Access Compliance Report

Public Rights-of-Way

(Curb Ramps)

Intersection ID: 29959	Main Street: STATESVILLE_RD	Cross Street: SMITH_CORNERS_BV	Location: NE
ADA ID: 8964A5973A4C	Ramp Type: Perp	Initial Pass/Fail: Fail	Overall Compliance: No
Severity Score: 12.5			
Codes/Mitigation Info/Possible Solution		Field Measurements/Component Compliance

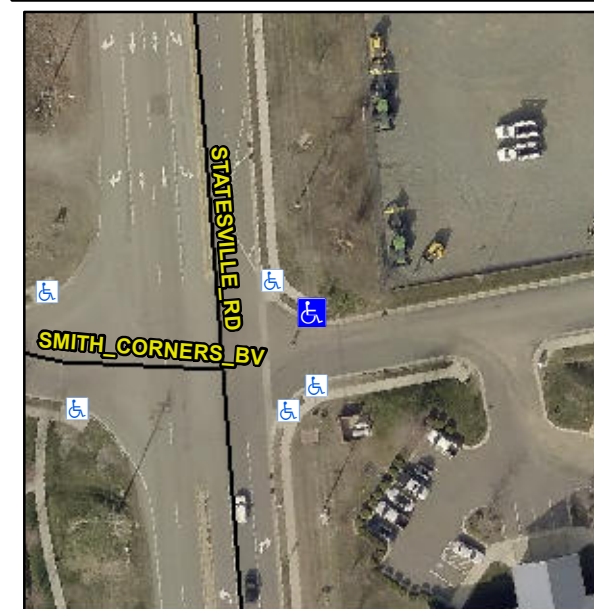
R304.2.2

Compliance	Description	Data	Compliance	Description	Data
N/A	Ramp Length (in)	47.0	No	Ramp Slope (%)	10.4
Yes	Ramp Width (in)	48.0	Yes	Ramp XSlope (%)	2.0
N/A	Flare Type LT	N/A	N/A	Flare Type RT	N/A
N/A	Flare Slope LT (%)	N/A	N/A	Flare Slope RT (%)	N/A
N/A	Flare Traversable LT?	N/A	N/A	Flare Traversable RT?	N/A
N/A	Landing Length (in)	N/A	N/A	DWS Provided?	N/A
N/A	Landing Width (in)	N/A	N/A	DWS Contrast?	N/A
N/A	Landing Slope (%)	N/A	N/A	DWS Length (in)	N/A
N/A	Landing X Slope (%)	N/A	N/A	DWS Full Width?	N/A
N/A	Landing Curb? (Y/N)	N/A	N/A	DWS Offset (in)	N/A
N/A	Shared Landing?	N/A			
N/A	Gutter Ponding?	N/A	N/A	Gutter Slope (%)	N/A
N/A	Gutter Lip Ht (in)	N/A	N/A	Gutter X Slope (%)	N/A
N/A	Painted X Walk1?	No	N/A	Painted X Walk2?	N/A
	X Walk 1 Direction	To S		X Walk 2 Direction	N/A
N/A	X Walk 1 Width (in)	N/A	N/A	X Walk 2 Width (in)	N/A
	X Walk 1 Slope (%)	0.9		X Walk 2 Slope (%)	N/A
	X Walk 1 X Slope (%)	1.8		X Walk 2 X Slope (%)	N/A

Remove & Replace Entire Ramp.
